TPS65951 Silicon Errata

This document describes the TPS65951 bugs, limitations, and enhancements with suggested workarounds.

Figure 1. Block Diagram of HFCLKOUT Gating

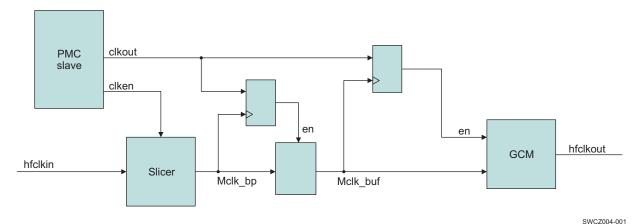
9 Spikes occur on HFCLKOUT during switch on following an asynchronous switch off Impact:

After an asynchronous switch off (that is, PWRON_8s or WD-event), spikes occur on HFCLKOUT during the next switch on. The spikes occur after CLKEN is asserted, but before NRESPWRON is asserted. Because they occur before NRESPWRON, there should be no system impact.

Globally, HFCLKOUT is gated by the clkout signal resync on mclk, which is present only when clken is available (and hfclkin is present). See Figure 1.

- Normal/controlled switch off:
 - clkout is switched off before clken → the mclk clock is available after clkout goes low and the resynchronized enable of hfclkout GCM is properly disabled.
- PWRON_8s and any "async" switch-off events like watchdog:
 - clkout and clken are reset together → the resynchronized enable stays high until the next mclk clock cycle, which comes during the next switch on (when clken and hfclkin are present), so the hfclkout will be gated after one or two hfclkin clock cycles only. Due to this, spikes are seen on HFCLKOUT during the switch on following an asynchronous switch off.

No workaround.
